Product Change Notification

Change Notification #: 113441 - 00
Change Title: Intel® Server System R1208GL4DS
PCN 113441-00
Product Design, Label
Update the System Rear Panel, Quick
Reference Label and Add a Mylar and a
Plastic Block
Date of Publication: November 21, 2014

Figure One

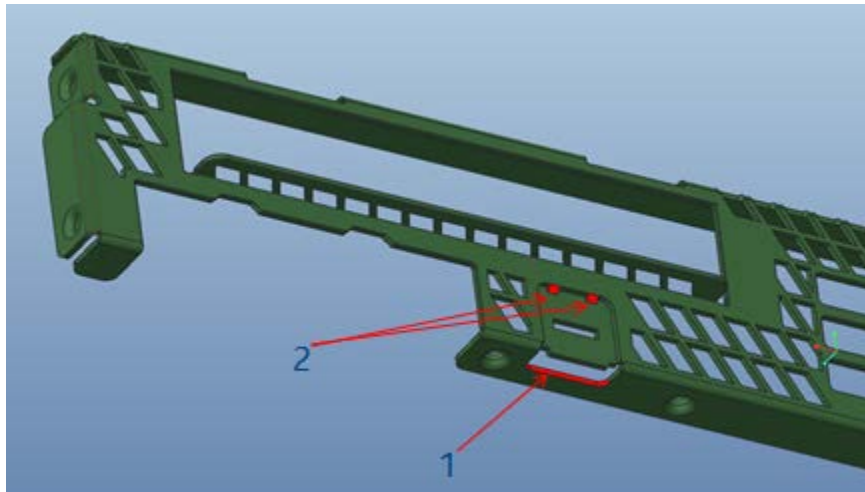
1. Add a connection at the bottom of the RMM4 (Remote Management Module 4) slot to improve structure strength. See item 1 in the Figure One.
2. Update the one big center joint to two smaller joints so that the joints will not conflict with the LAN cable connector latch. See item 2 in the Figure One.

Figure Three

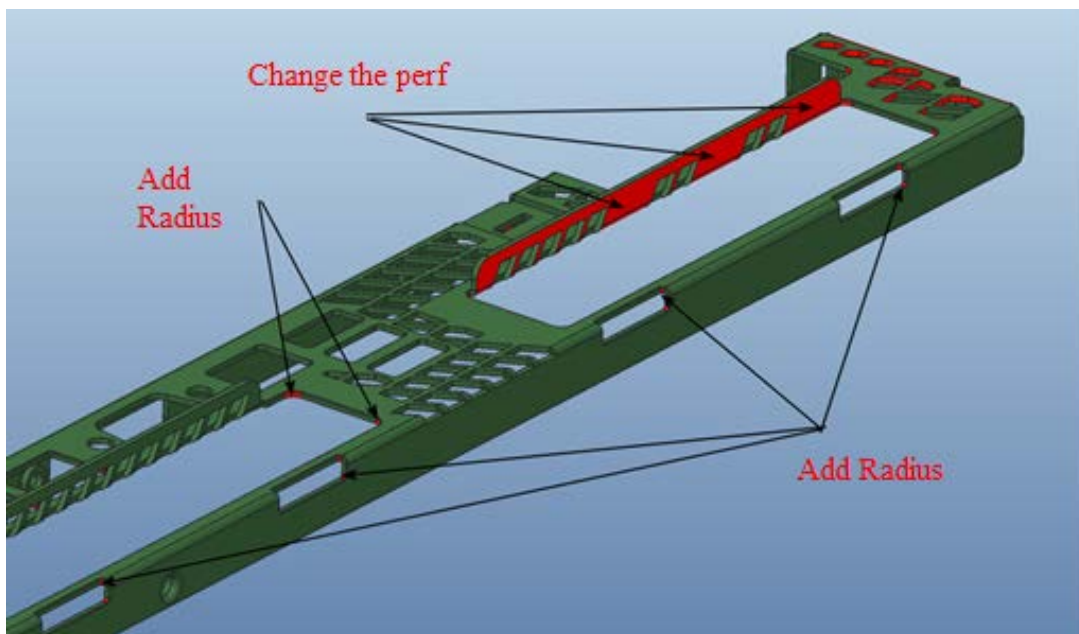
4. Update the perf and add radius to improve structure strength. See the Figure Three and Four.

Figure Five

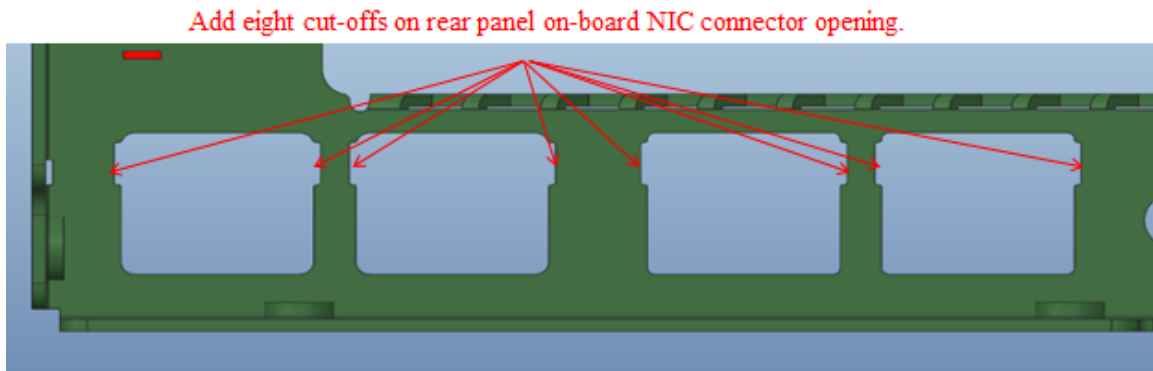
5. Add eight cut-offs around the on-board NIC (Network Interface Controller) openings to improve the LED visibility. See the Figure Five.

Figure Six

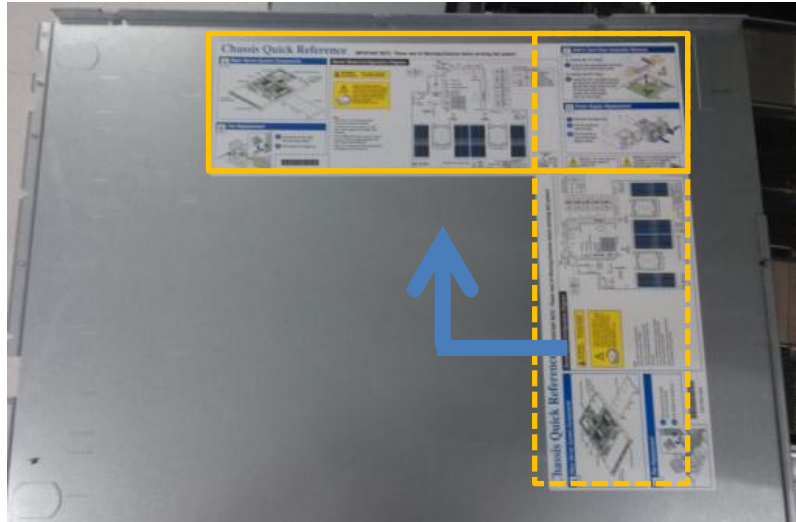
6. Rotate the orientation of the Quick Reference Label by 90 degree. The new location of the label is above the power supply unit cage and the air duct. See the Figure Six.
